**AMENDMENTS TO THE DRAWINGS**

### **REMARKS**

### **In the Drawings**

FIG. 2  
(PRIOR ART)

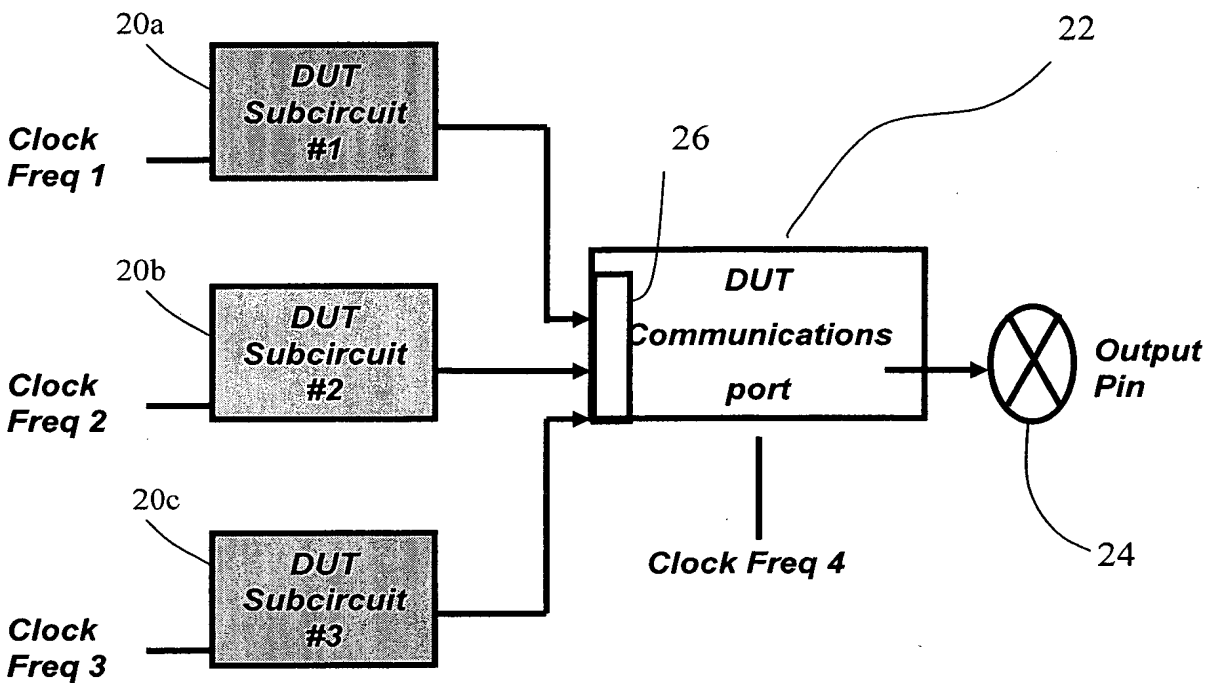
The Examiner has objected to FIGS. 2 and 3 because the legend does not indicate the figures show the prior art. The enclosed replacement sheet should remove this objection.

The present application describes testing semiconductor devices in which multiple subcircuits may be connected to an output pin through a communications port (See FIG. 2). During operation of the semiconductor device, each of the subcircuits may operate subject to timing variations. Because each of the subcircuits operates independently, each may be subject to a different timing variation.

The attached sheet(s) of drawings includes changes to Figures 2 and 3.
